## ADDENDUM 2

Project: Duckabush Line Relocation Project

Date: 3/22/2024

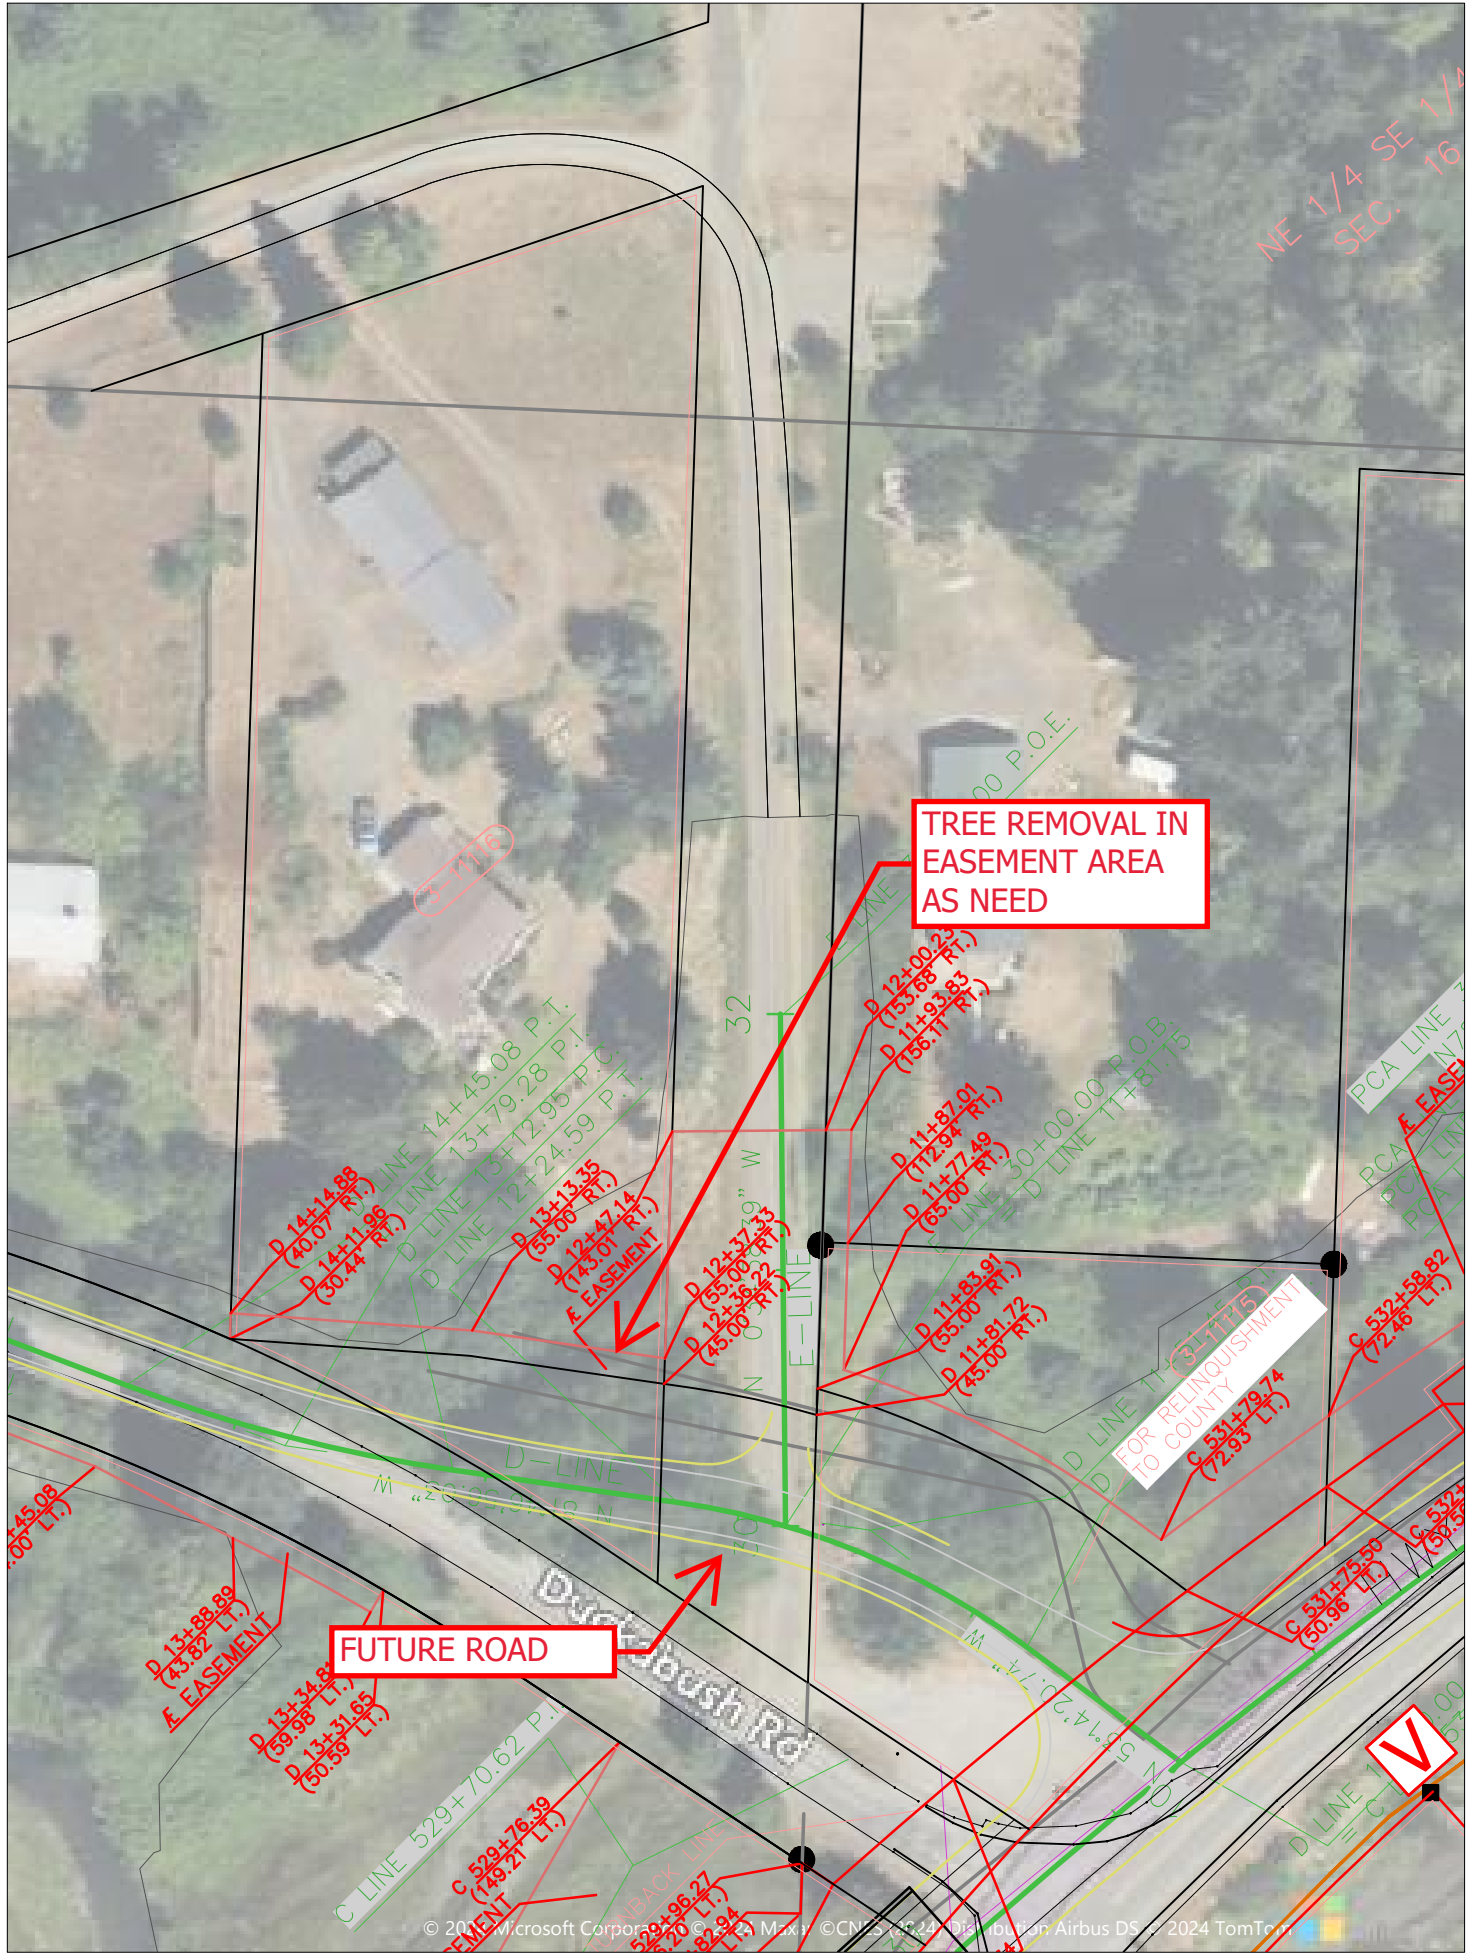
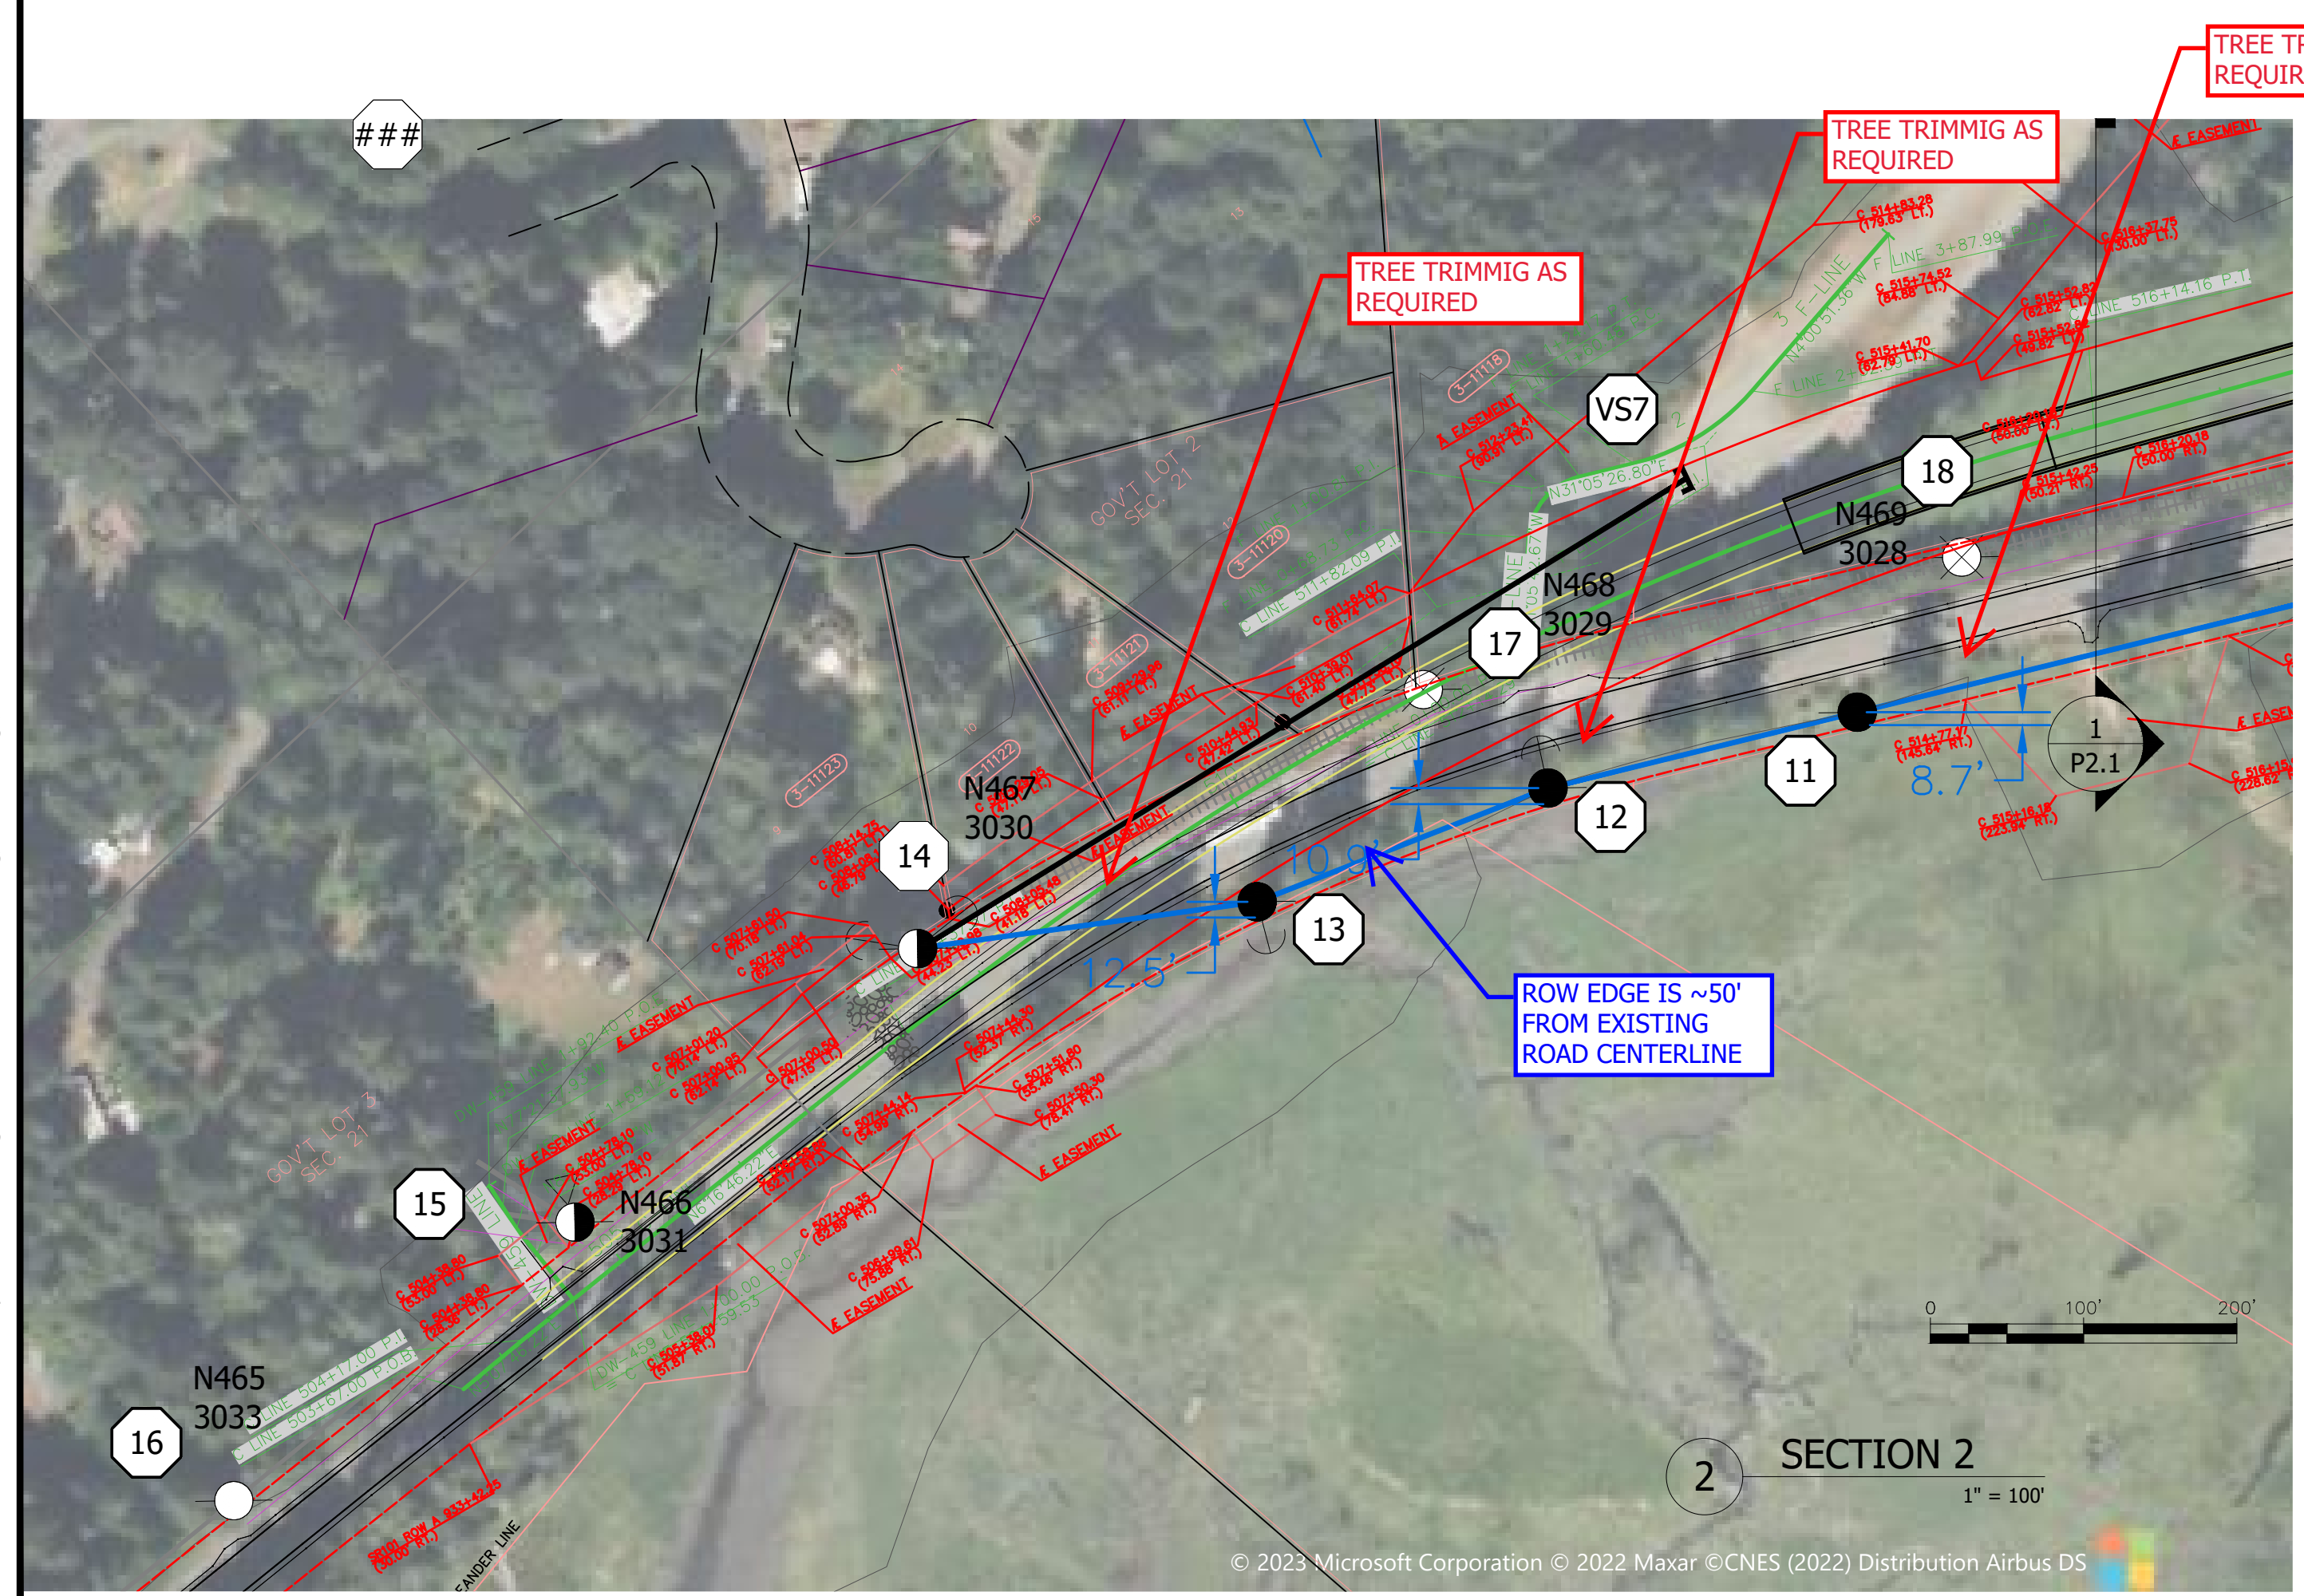
- a. Tree removal may be necessary near the vault and cabinet locations VN5 & VN6 and JN1. Refer to plan drawings P1.2 and D1.1 – Detail 1.
  - i. See attached PDFs “VN5-VN6 Tree Removal 1” and “VN5-VN6 Tree Removal 2.”
- b. Tree trimming assumes the minimum necessary amount to energize line.
  - i. See attached PDF “P2.1T” for pruning standards.

TREE REMOVAL IN  
EASEMENT AREA  
AS NEED

**P2.1T**  
 4 / 7

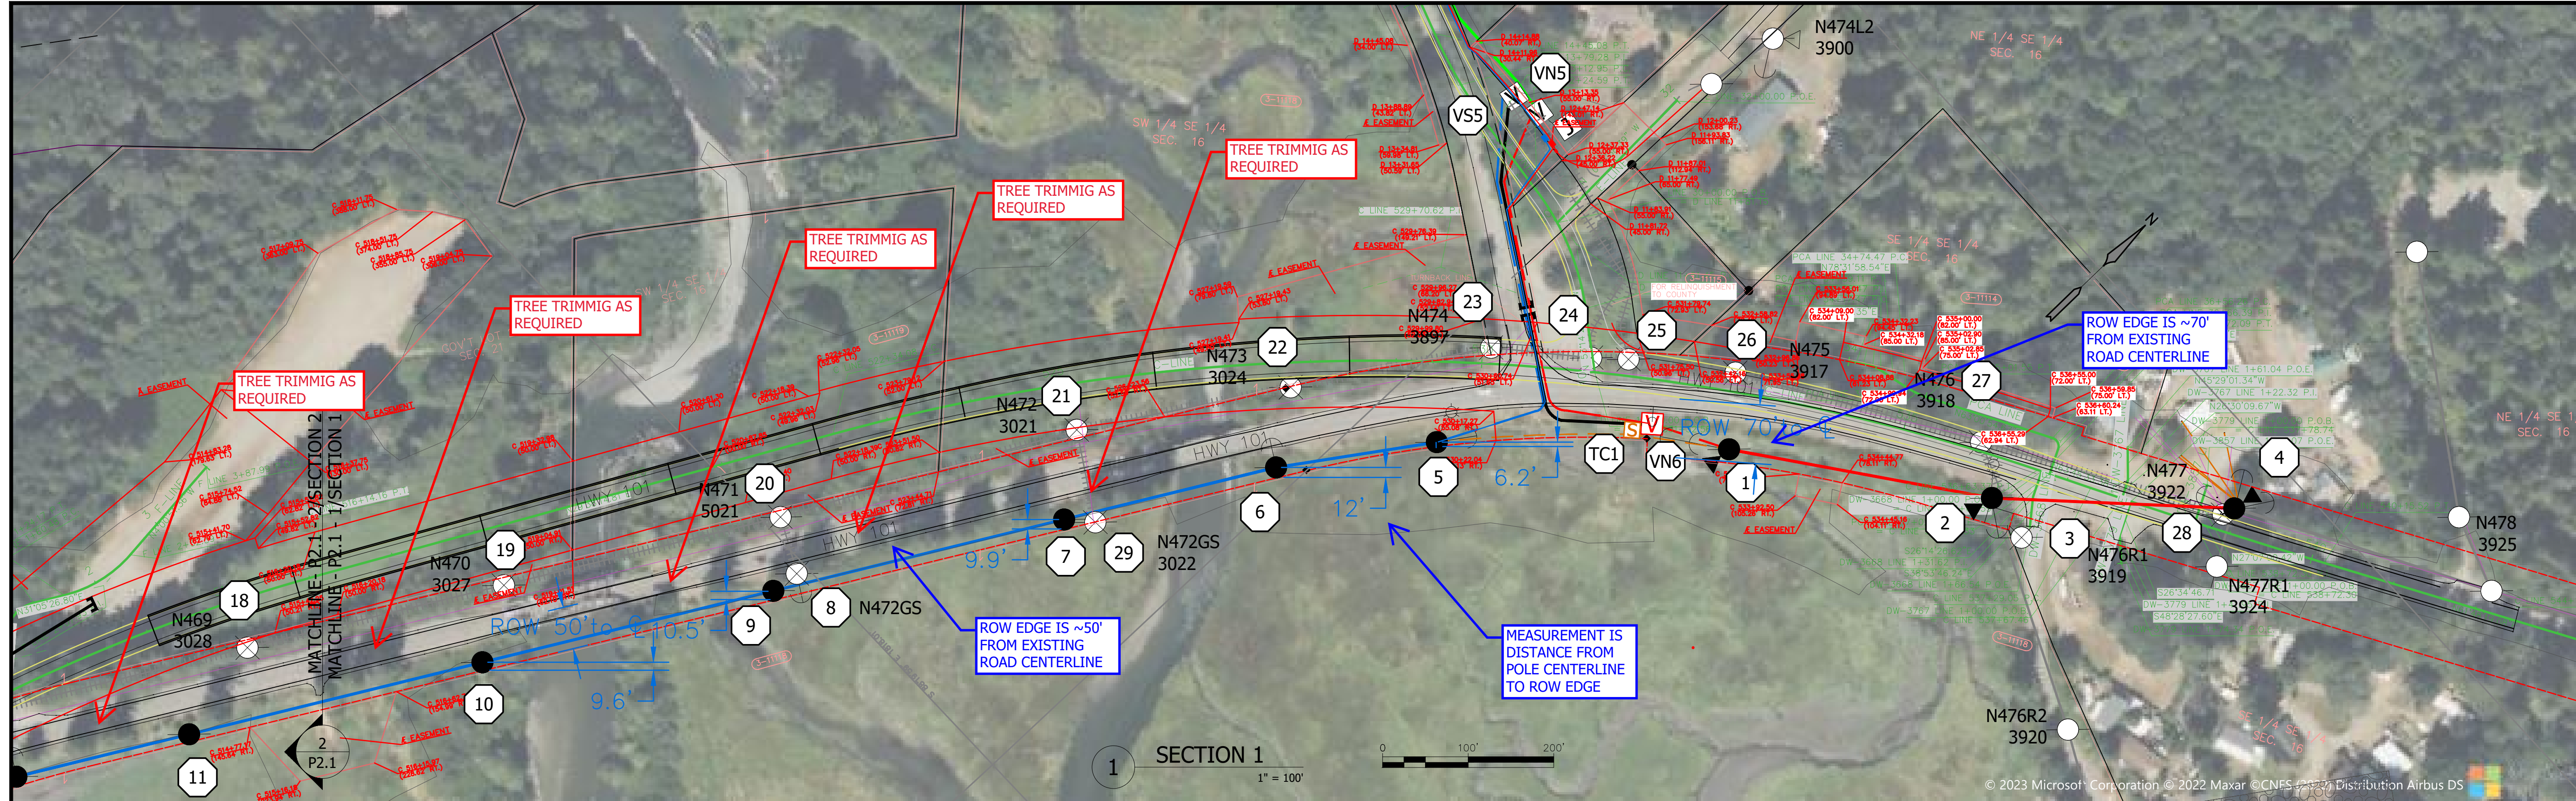
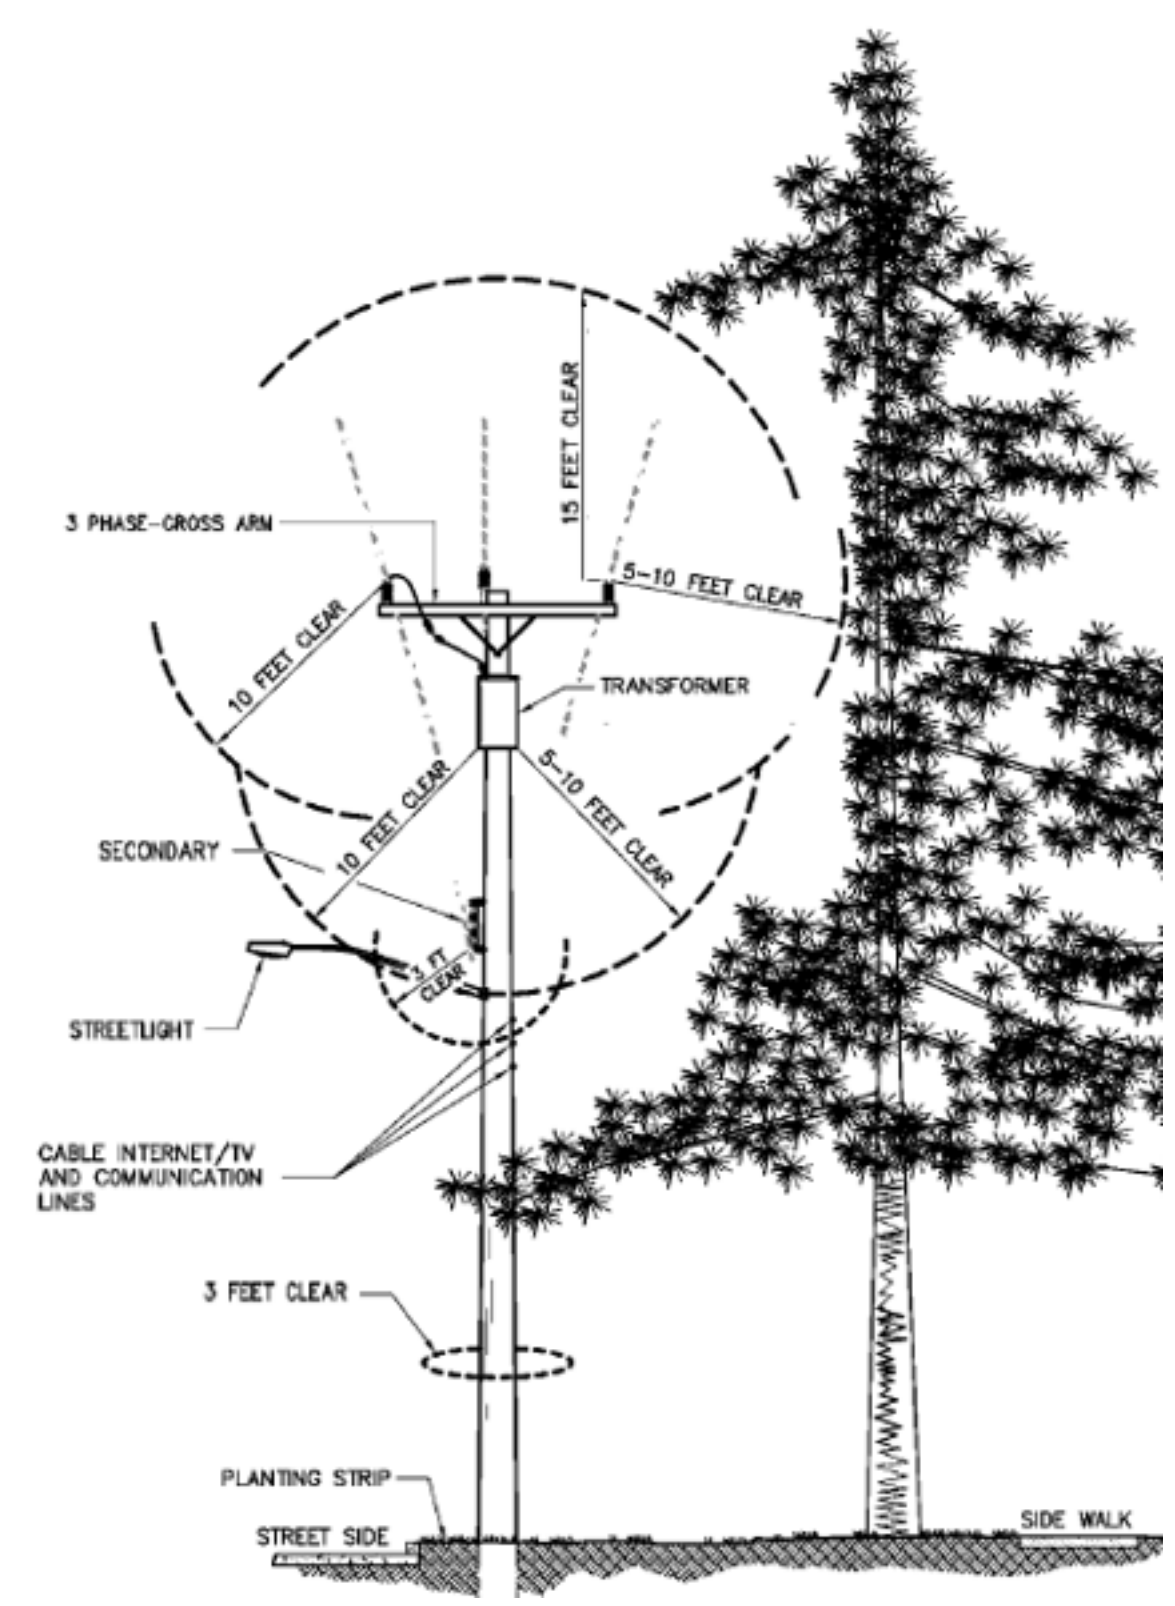
Three Phase Distribution Powerline, Side Pruning
